PIC18F47J13 Family Silicon Errata and Data Sheet Clarification

The PIC18F47J13 Family devices that you have received conform functionally to the current Device Data Sheet (DS39974A), except for the anomalies described in this document.

The following typographic corrections and clarifications are to be noted for the latest version of the device data sheet (DS39974A):

FIGURE 2-3 FREQUENCY vs. ESR PERFORMANCE FOR SUGGESTED VCAP

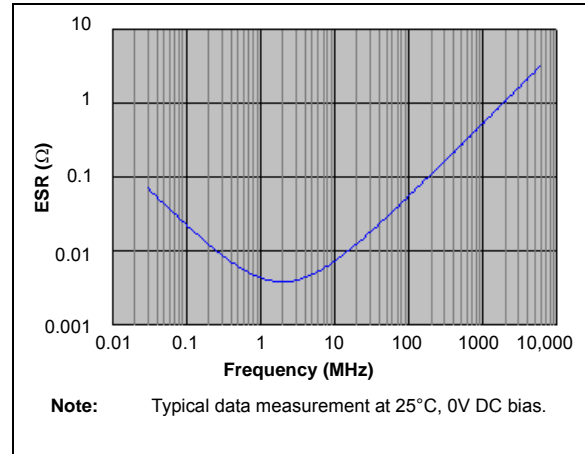
Section “2.4 Voltage Regulator Pins (VCAP/VDDCORE)” has been replaced with a new and more detailed section. The entire text follows:

Designers may use [Figure 2-3](#) to evaluate ESR equivalence of candidate devices.

On “F” devices, a low-ESR ($< 5\Omega$) capacitor is required on the VCAP/VDDCORE pin to stabilize the voltage regulator output voltage. The VCAP/VDDCORE pin must not be connected to VDD and must use a capacitor of 10 μF connected to ground. The type can be ceramic or tantalum. Suitable examples of capacitors are shown in [Table 2-1](#). Capacitors with equivalent specifications can be used.

It is recommended that the trace length not exceed 0.25 inch (6 mm). Refer to [Section 30.0 “Electrical Characteristics”](#) for additional information.

FIGURE 2-4 DC BIAS VOLTAGE vs. CAPACITANCE CHARACTERISTICS

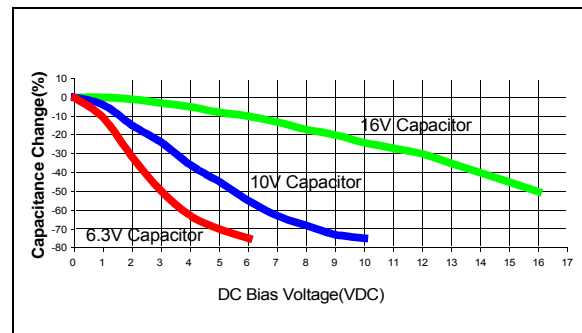
A typical DC bias voltage vs. capacitance graph for 16V, 10V and 6.3V rated capacitors is shown in Figure 2-4.

When selecting a ceramic capacitor to be used with the internal voltage regulator, it is suggested to select a high-voltage rating, so that the operating voltage is a small percentage of the maximum rated capacitor voltage. For example, choose a ceramic capacitor rated at 16V for the 2.5V core voltage. Suggested capacitors are shown in Table 2-1.
